TECHNICAL NEWS

Bulletin Nbr: 98-09

Date:.....SEPTEMBER 1998

Blocked hose on EVAP canister**Cars affected**

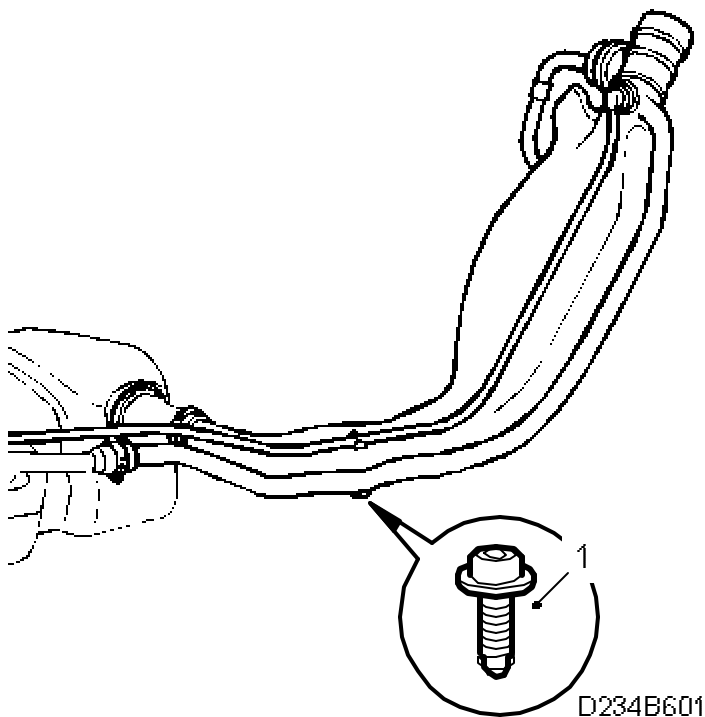
The hose on the EVAP canister on a small number of cars may have been bent due to incorrect assembly on the production line. This can block the system and cause a number of faults that can not primarily be traced to this cause, e.g.

- Engine stalls and can be restarted after a couple of hours.
- Loss of power.
- Vibration during acceleration.
- DTC P0172 displayed on the diagnostic tool.

- Incorrect fuel gauge reading.
- The fuel tank can be deformed so much that it can even be completely compressed after a time. Check the pump and fuel sensor.

If a car displays one or any of the problems described above, check the hoses on the EVAP canister and adjust their positions if necessary. See illustration.
